Access Compliance Report

Public Rights-of-Way

(Curb Ramps)

Intersection ID: 29150	Main Street: DEATON_HILL_DR	Cross Street: HIGHLAND_PARK_DR	Location: NE
ADA ID: 494D0A631B18	Ramp Type: Perp	Initial Pass/Fail: Fail	Overall Compliance: No
Severity Score: 1.25			
Codes/Mitigation Info/Possible Solution		Field Measurements/Component Compliance

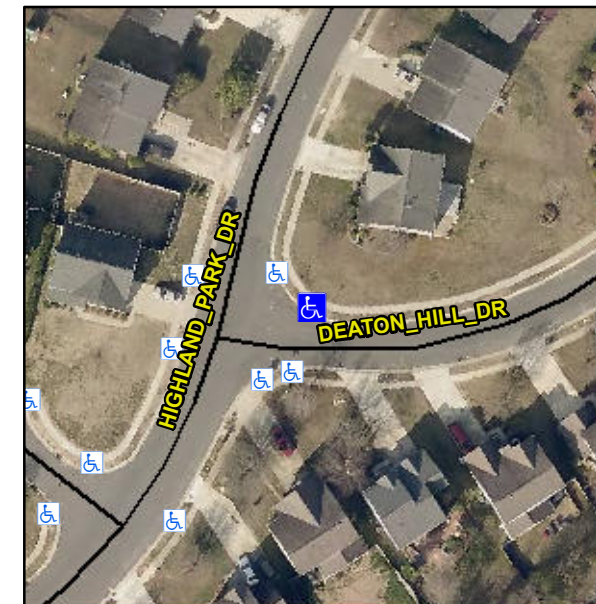
R304.5.3

Compliance	Description	Data	Compliance	Description	Data
N/A	Ramp Length (in)	46.0	Yes	Ramp Slope (%)	5.3
Yes	Ramp Width (in)	48.0	No	Ramp XSlope (%)	2.6
N/A	Flare Type LT	N/A	N/A	Flare Type RT	N/A
N/A	Flare Slope LT (%)	N/A	N/A	Flare Slope RT (%)	N/A
N/A	Flare Traversable LT?	N/A	N/A	Flare Traversable RT?	N/A
N/A	Landing Length (in)	N/A	N/A	DWS Provided?	N/A
N/A	Landing Width (in)	N/A	N/A	DWS Contrast?	N/A
N/A	Landing Slope (%)	N/A	N/A	DWS Length (in)	N/A
N/A	Landing X Slope (%)	N/A	N/A	DWS Full Width?	N/A
N/A	Landing Curb? (Y/N)	N/A	N/A	DWS Offset (in)	N/A
N/A	Shared Landing?	N/A			
N/A	Gutter Ponding?	N/A	N/A	Gutter Slope (%)	N/A
N/A	Gutter Lip Ht (in)	N/A	N/A	Gutter X Slope (%)	N/A
N/A	Painted X Walk1?	No	N/A	Painted X Walk2?	N/A
	X Walk 1 Direction	To S		X Walk 2 Direction	N/A
N/A	X Walk 1 Width (in)	N/A	N/A	X Walk 2 Width (in)	N/A
	X Walk 1 Slope (%)	4.1		X Walk 2 Slope (%)	N/A
	X Walk 1 X Slope (%)	3.5		X Walk 2 X Slope (%)	N/A

Remove & Replace Entire Ramp.
